Work Order ID 107613

Item Name: Aft Crosstube - High

DRAWING NO. D412-664-243	TITLE CROSSTUBE ASS'Y (412 HI AFT)	REV. E	DART AEROSPACE LTD ENGINEERING ORDER		D.E.O. NO. D412-664-243-E-2	SHEET NO. SHEET 1 OF 1	SCALE NTS
DRAWN qp	CHECKED AS	MFG. APPR. E	APPROVED MP		DE APPR. -H		
DATE 11.09.07	DATE 11.09.19	DATE 11.09.19	DATE 11.09.19		DATE 11.09.19

DRAWING NO. D412-664-243	TITLE CROSSTUBE ASSEMBLY (412 HI AFT)	REV. E	DART AEROSPACE LTD ENGINEERING ORDER		D.E.O. NO. D412-664-243-E-4	SHEET NO. SHEET 1 OF 3	SCALE NTS
DRAWN 90	CHECKED A	MFG. APPR. A	APPROVED MP		DE APPR. MP		
DATE 12.08.21	DATE 12.08.30	DATE 12.08.30	DATE 12/8/30		DATE 12.08.30

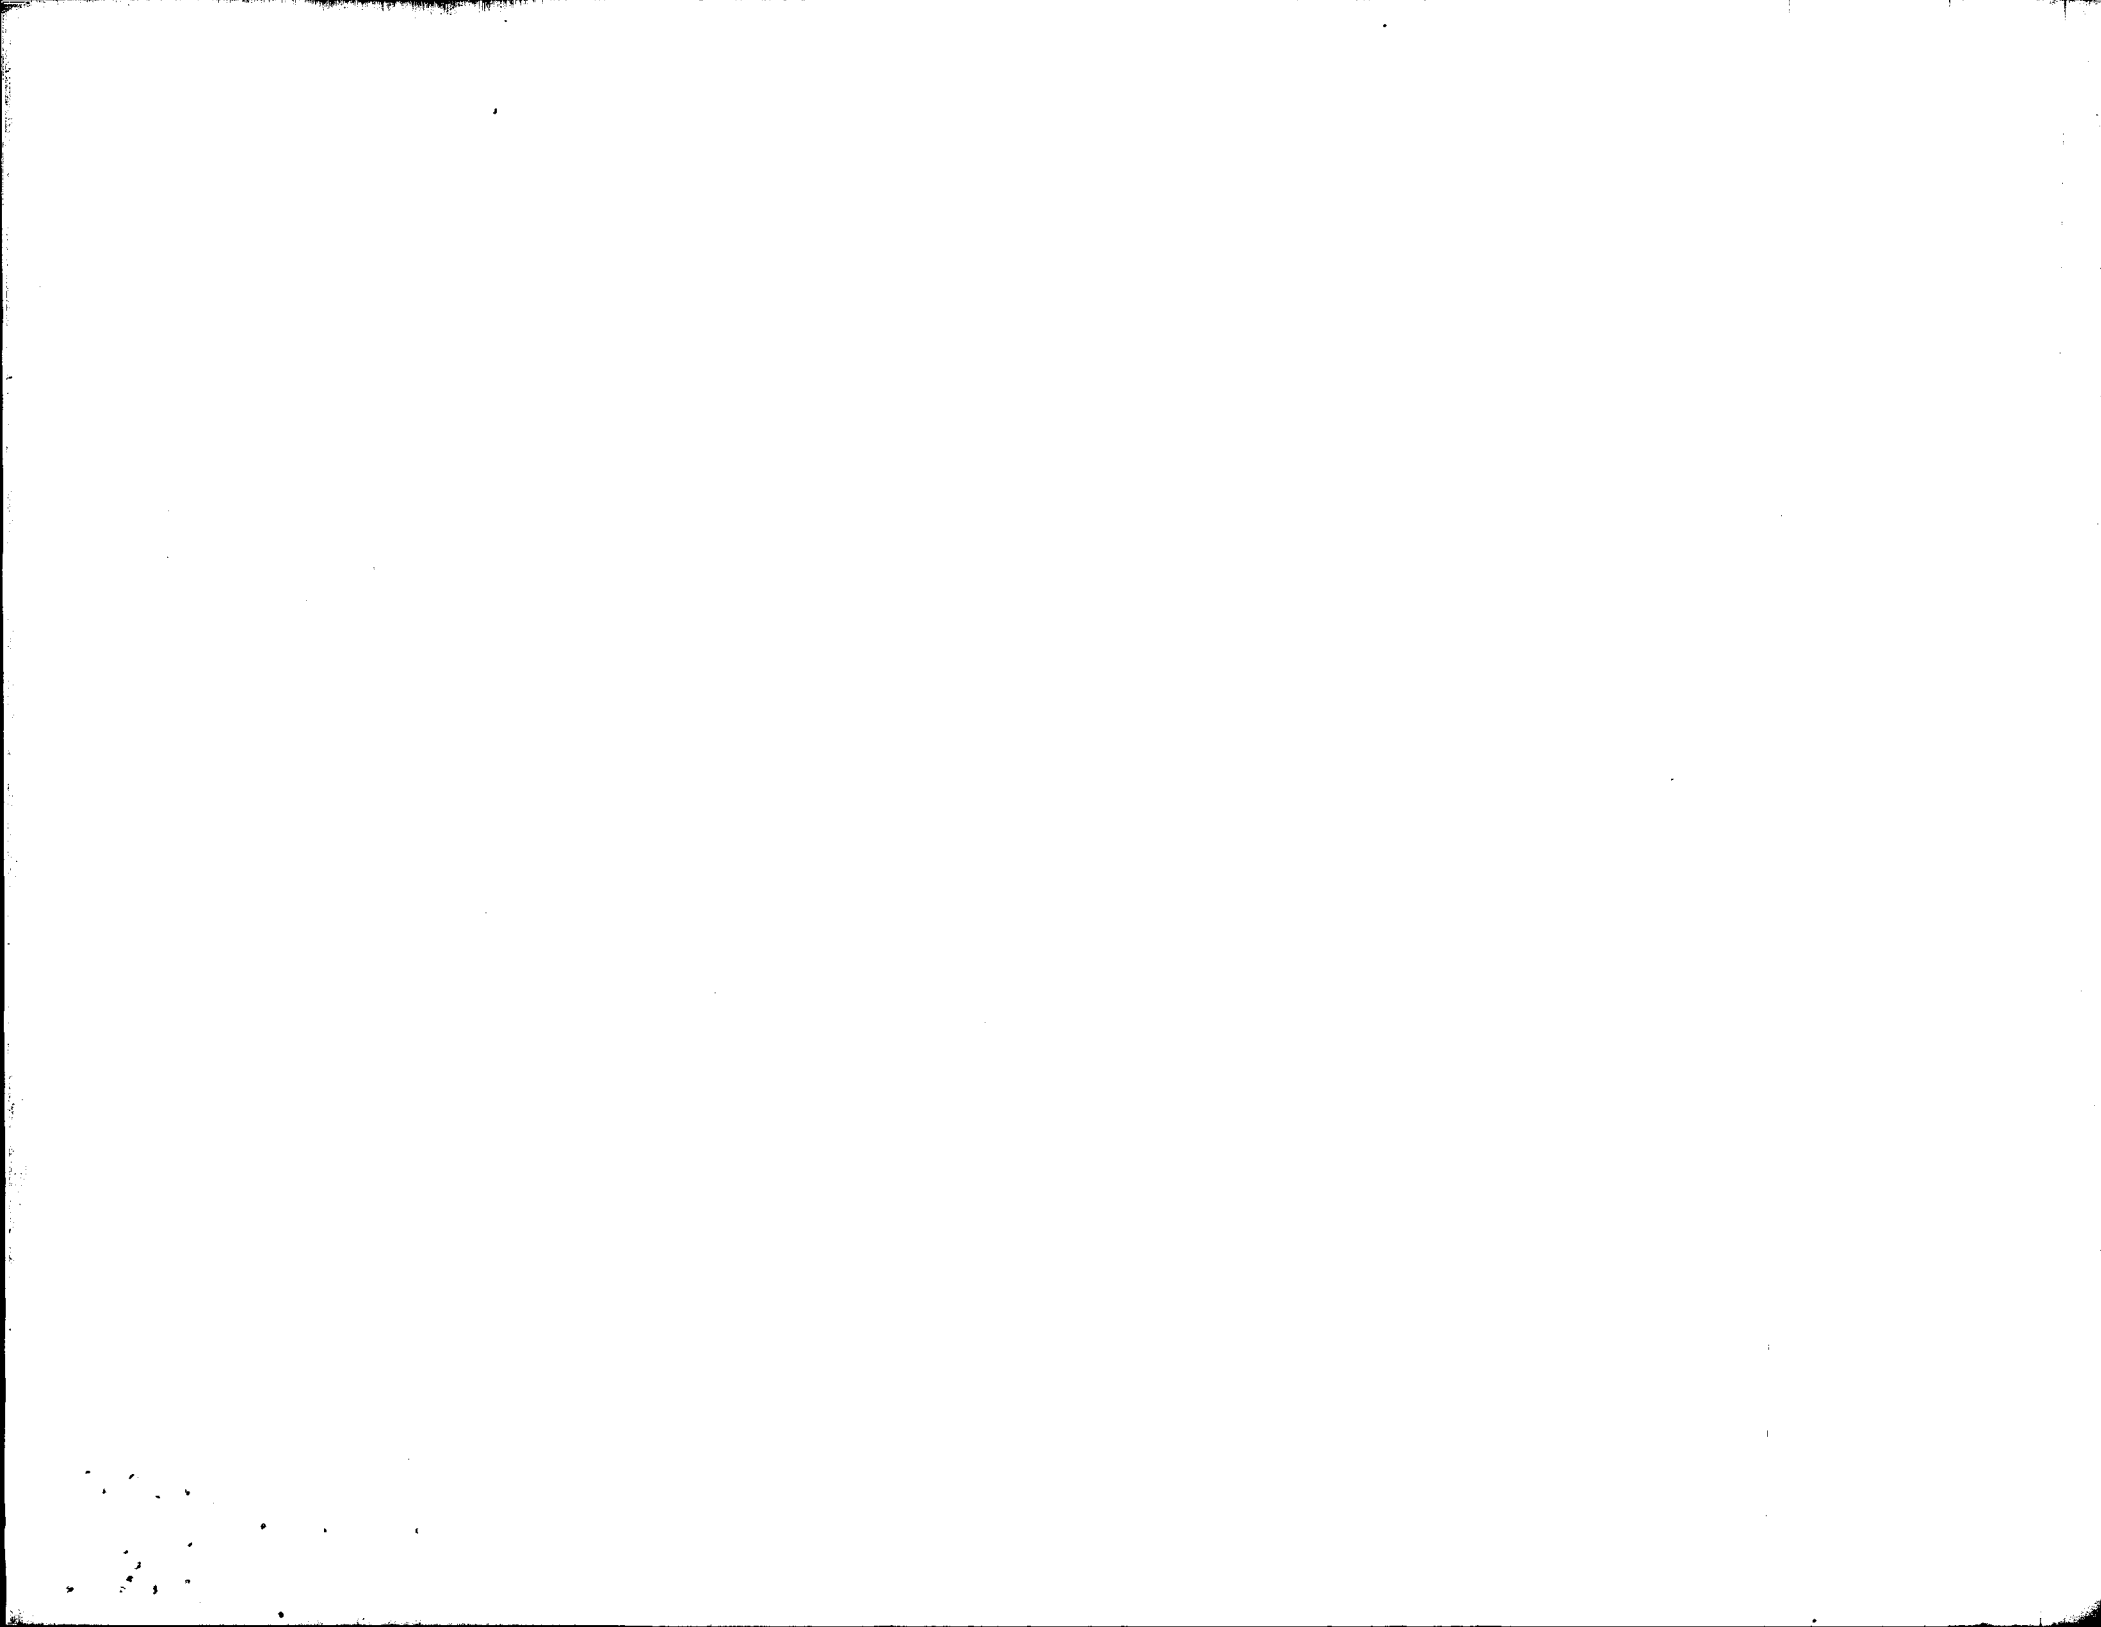
REPLACE MAGNOBOND WITH 3M DP460 SCOTCH-WELD EPOXY ADHESIVE

NOTE 12 & 16, SHEET 1 IS AMENDED AS FOLLOWS:

- 12) INSTALL D2896-1 CENTER SUPPORT USING A 0.04" TO 0.07" THICK LAYER OF SCOTCH-WELD DP460 PER QSI 015. LET CURE FOR 24 HOURS AFTER INSTALLATION AND PRIOR TO PACKAGING.
- 16) TORQUE CLAMPS 80 TO 100 IN-LB. ENSURE AT LEAST 1.5 THREADS SHOWING IN SAFETY AND THAT NUT HAS NOT BOTTOMED-OUT AFTER TORQUING. **PRIOR TO PACKAGING, RE-CHECK TORQUE ON CLAMPS AFTER ADHESIVE HAS CURED FOR 24 HOURS.**

**D412-664-243
ASSEMBLY DETAIL**

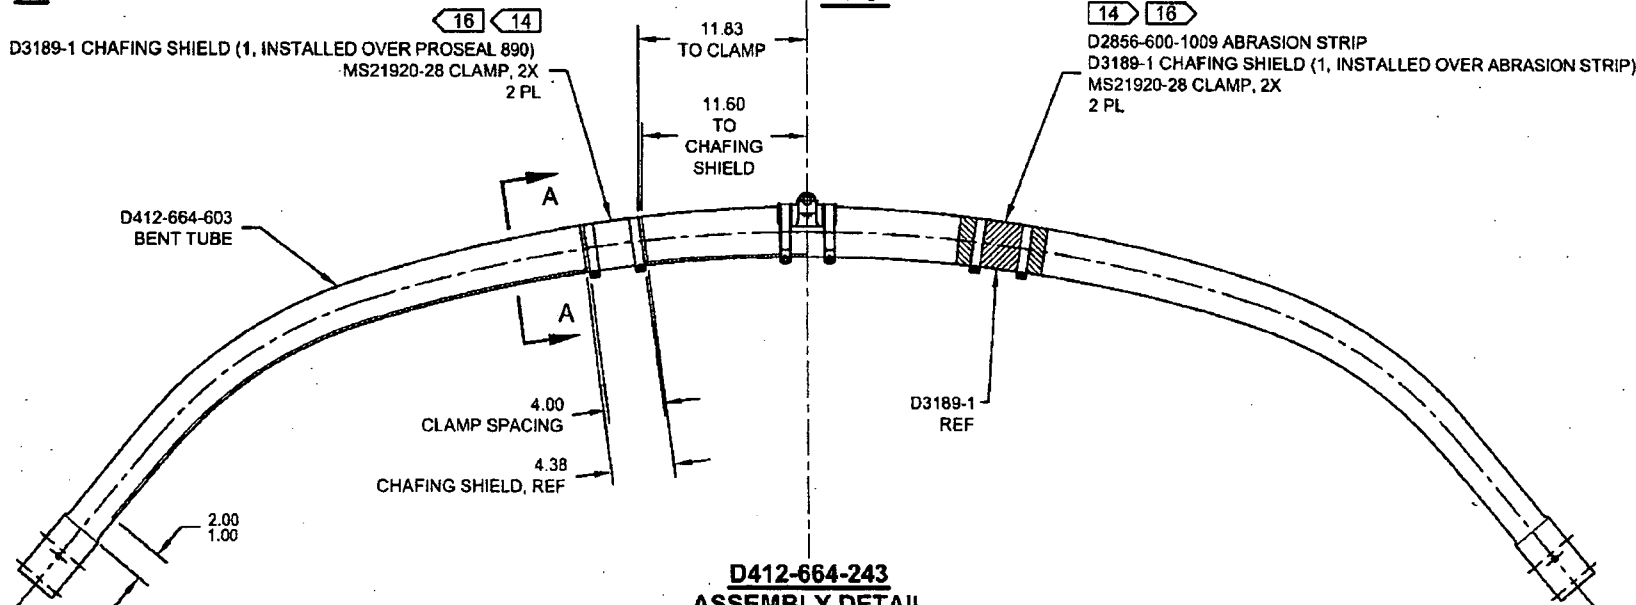
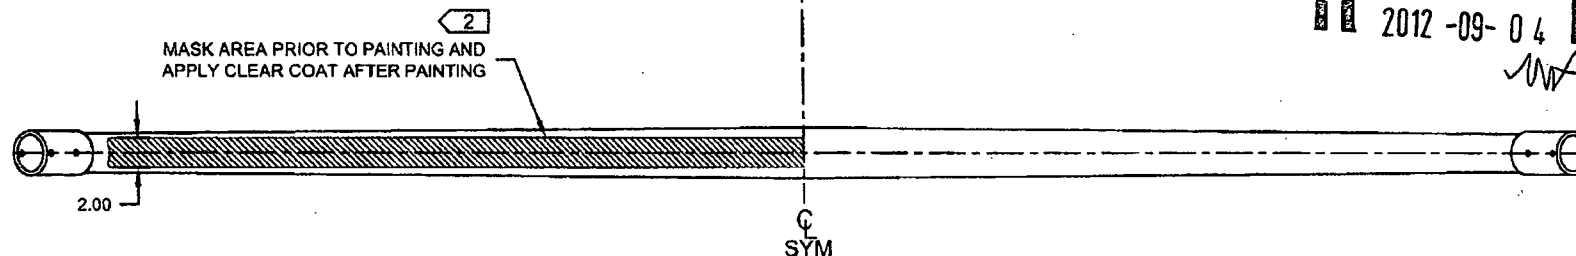
NOTES 2, 14, AND 16 ON SHEET 1 ARE AMENDED AS FOLLOWS:

WAS:

D2856-600-1009 ABRASION STRIP
D3189-1 CHAFING SHIELD (1, INSTALLED OVER ABRASION STRIP)
MS21920-28 CLAMP, 2X
2 PL

IS:

D3189-1 CHAFING SHIELD (1, INSTALLED OVER PROSEAL 890)
MS21920-28 CLAMP, 2X
2 PL
